## FIRST & CEDAR APARTMENTS

Studio apartments for currently homeless individuals

Early Design Guidance

April 8, 2008

**DEVELOP THE TERRACE AND GROUND LANDSCAPE**

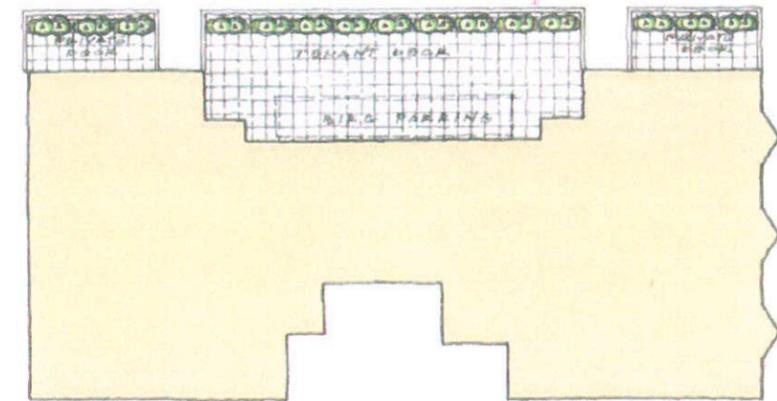
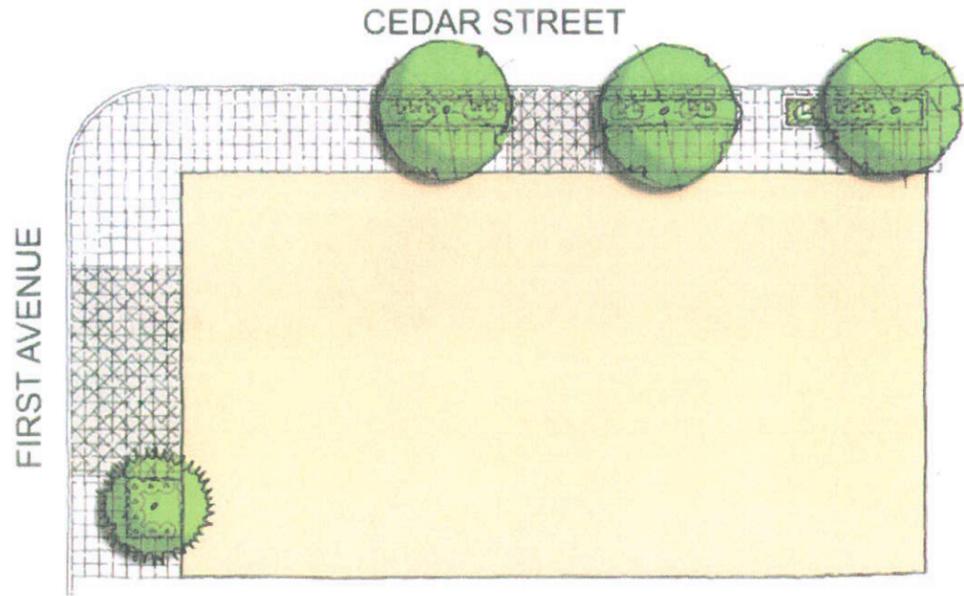
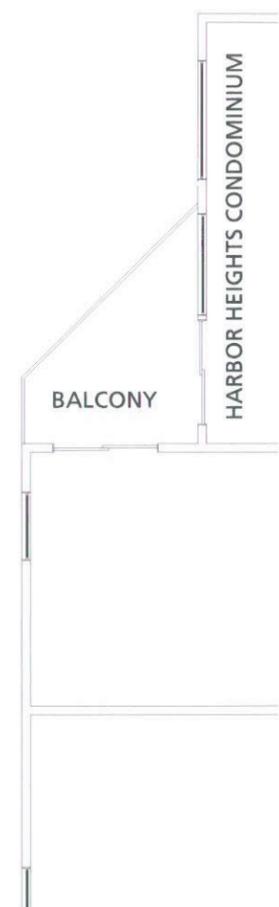
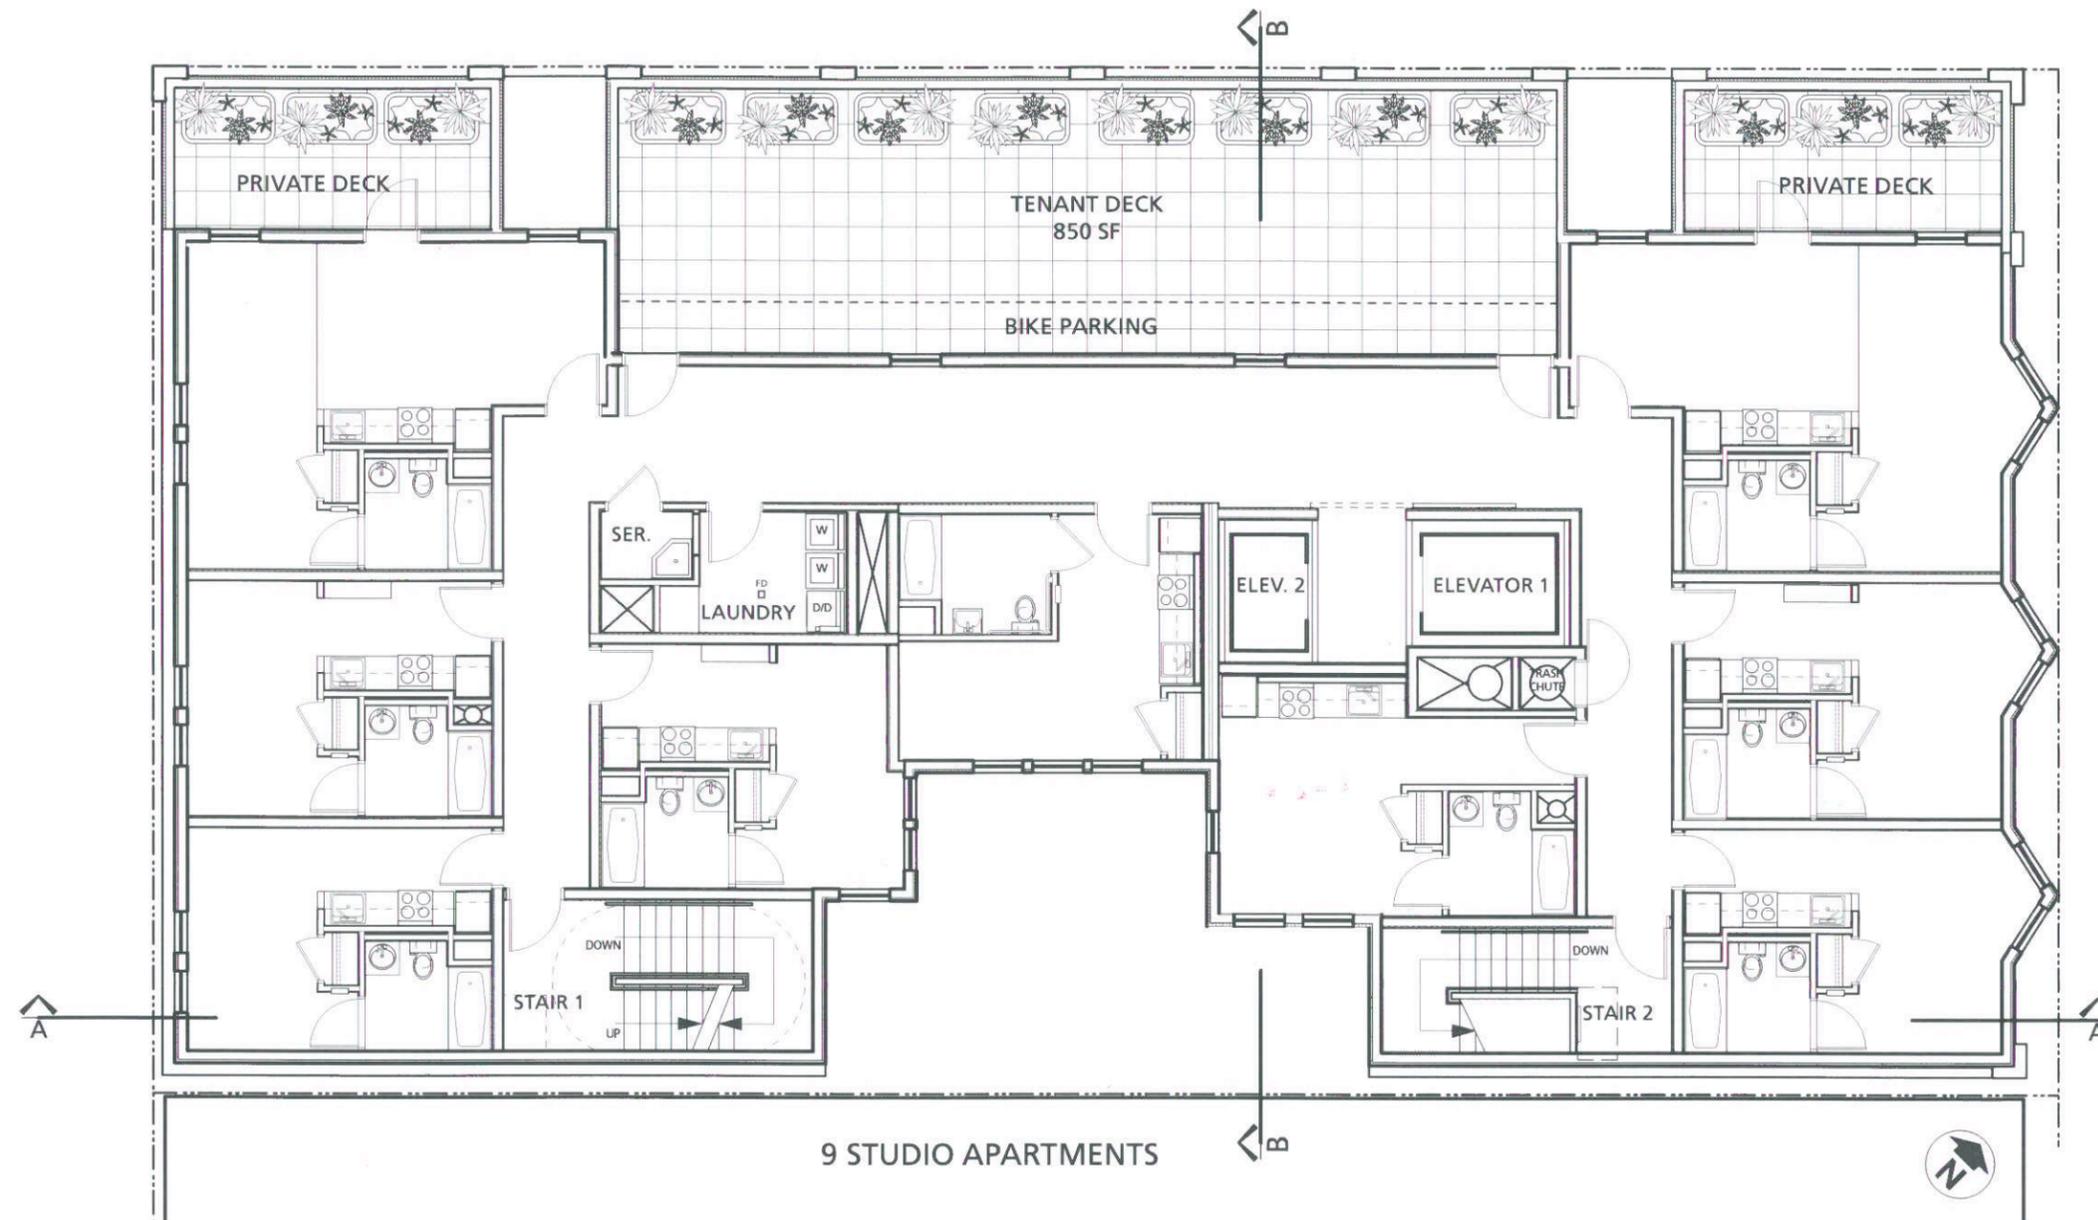
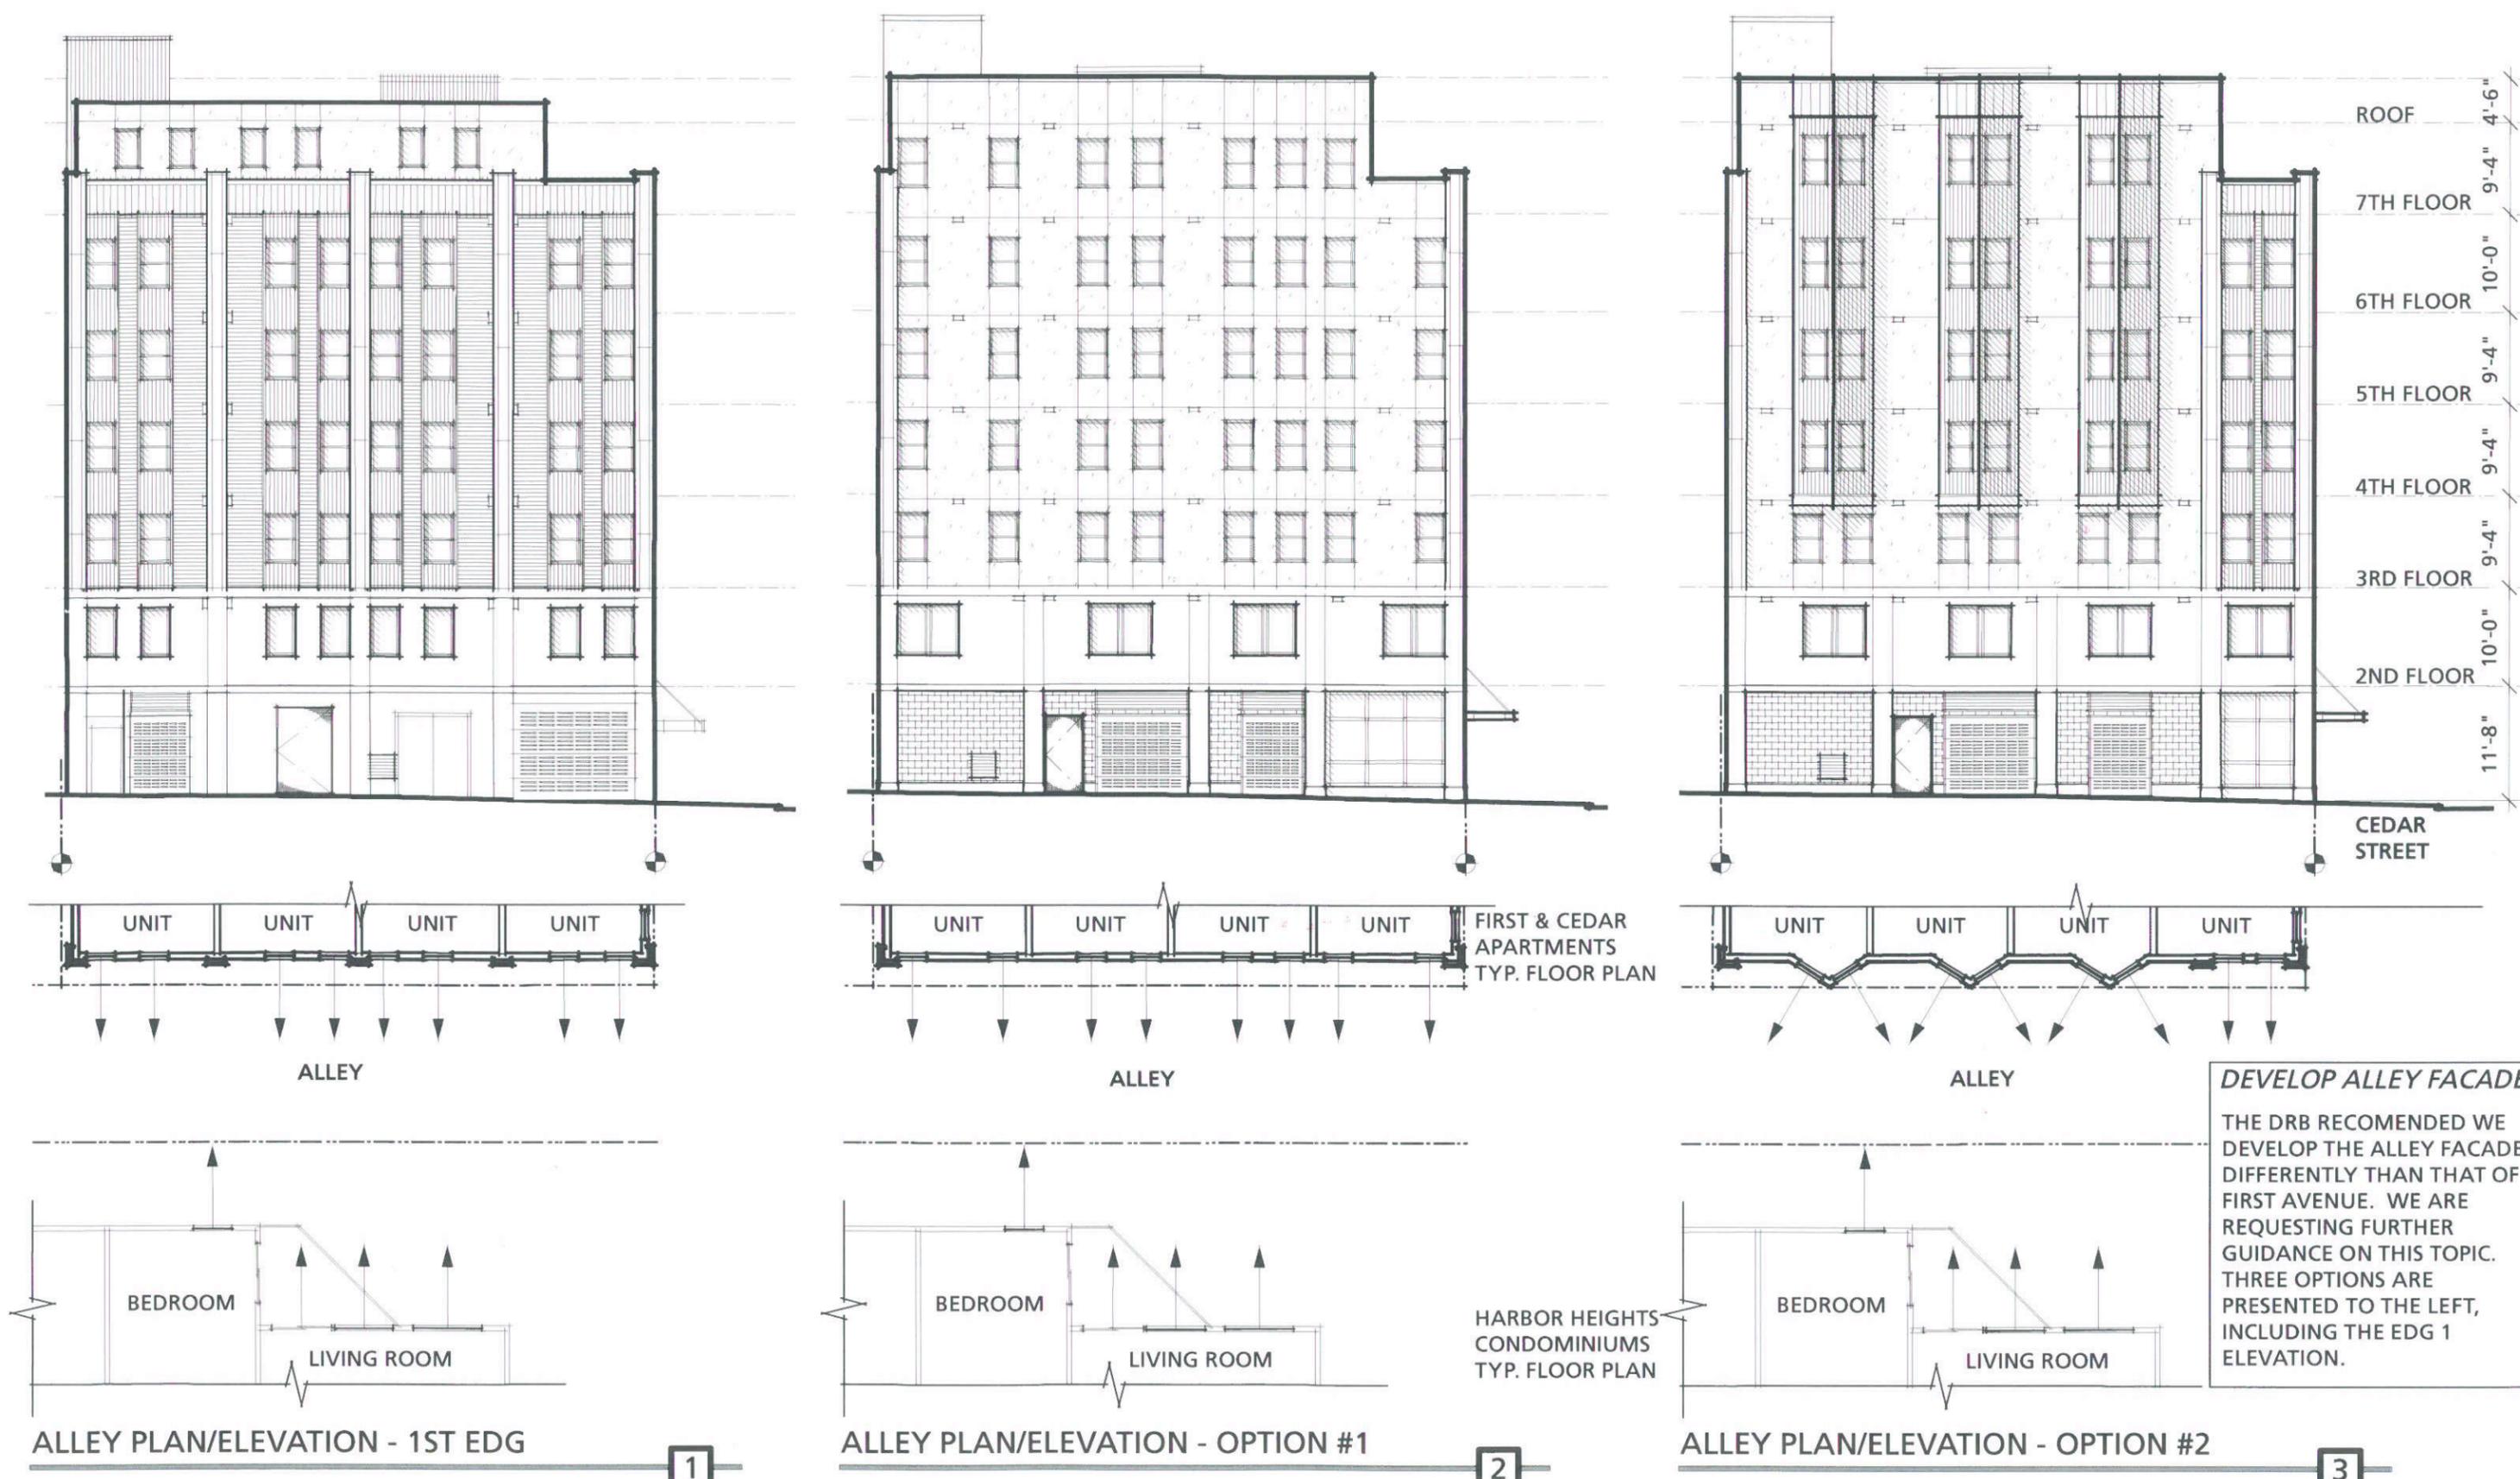
THE SEVENTH FLOOR DECKS (WHICH ARE APPROXIMATELY 1/3 OF THE BUILDING FOOTPRINT) WILL BE LANDSCAPED BEAUTIFULLY AND EXTENSIVELY. THESE DECKS ARE A RESULT OF THE GREEN STREET SETBACK REQUIREMENT AND WITH THAT IN MIND, WE HAVE PLANNED FOR LUSH, LOW-MAINTENANCE TROUGHS OF PLANTS OF VARYING HEIGHTS. SIMILAR TROUGHS HAVE BEEN USED ON OTHER PLYMOUTH PROJECTS WITH GREAT SUCCESS.

ON CEDAR STREET, WE ARE PROPOSING GREEN STREET LANDSCAPING IN FRONT OF THE RESIDENTIAL ENTRY. WE WILL USE THE EXISTING CEDAR TREE TO CREATE "WAITING BENCHES" IN FRONT OF THE MANAGERS' OFFICES.

THE FIRST AVENUE ARBORETEUM WILL CONTINUE WITH A REPLACEMENT CEDAR TREE ON FIRST, IN ADDITION TO RELOCATED STONE ART BENCHES. WE HAVE WORKED CLOSELY WITH THE ARTISTS BUSTER SIMPSON AND JACK MACKIE TO FOLLOW THE ORIGINAL CONCEPT FOR THIS AREA.
